2 Type of change

Change of material, V-Lock cord retaining feature as standard.

Product Change Notification					PCN GSP2 Appliance Inlet		
owner	creation date	release date	released by	change order no	rev	page	0118.2289
import	2015-12-05	2016-01-04	hotzar	2008799	A	1 of 2

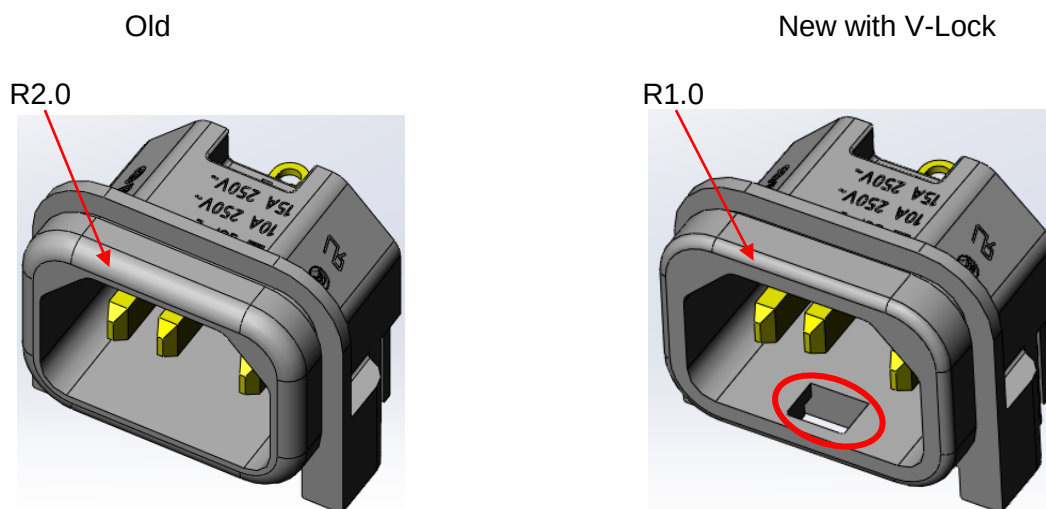
- Material change from PA6 to PA66/6 to pass the enhanced requirements of glow wire test acc. to IEC 60695-2-12 and -13
- V-Lock feature integrated as standard (not an option anymore)
- Radius on the front frame reduced from 2.0 to 1.0 mm

Form: Yes Socket has notch for V-Lock cord retaining and Radius on the front frame reduced from 2.0 to 1.0 mm
 Fit: No There are no dimensional changes
 Function: Yes V-Lock feature is standard (not an option anymore)
 Production Site: No There is no change of the production site
 Product Label: No No label change
